Attachment C

**Sydney Development Control Plan 2012
Policy and Housekeeping – Overview and
Explanation**

Figure 5.14

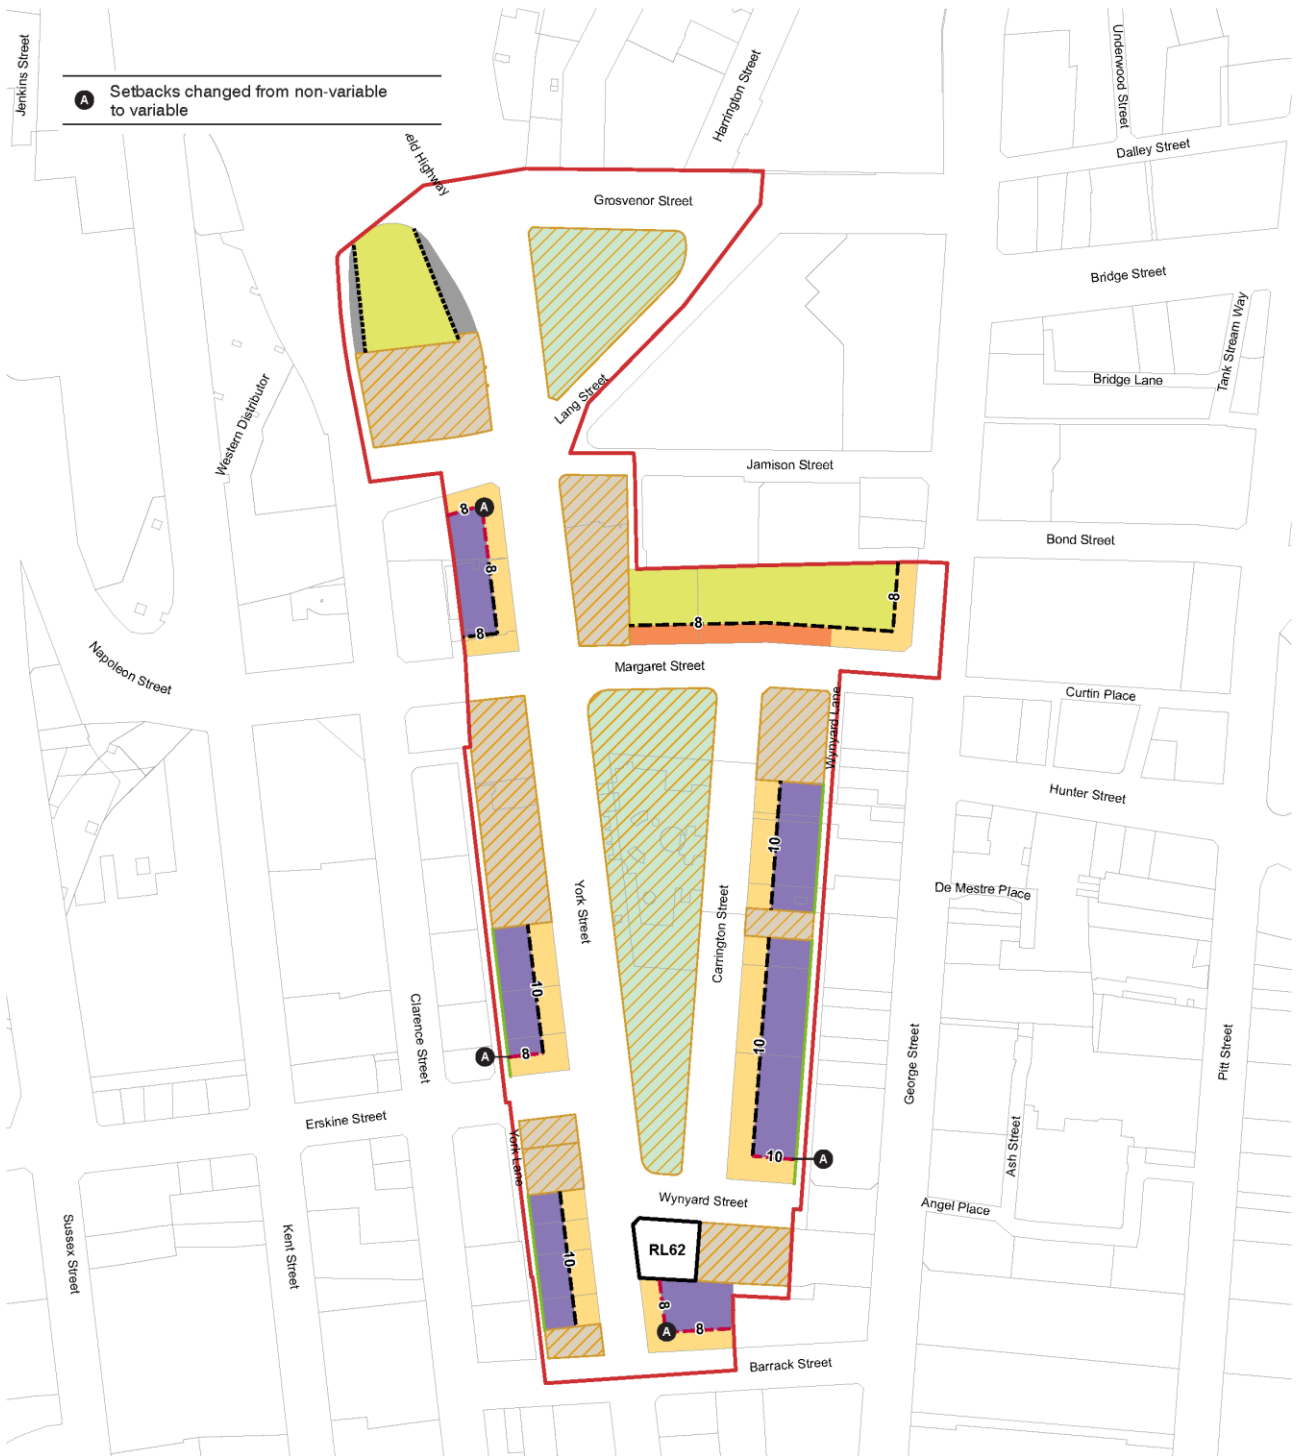
A Setbacks changed from non-variable to variable
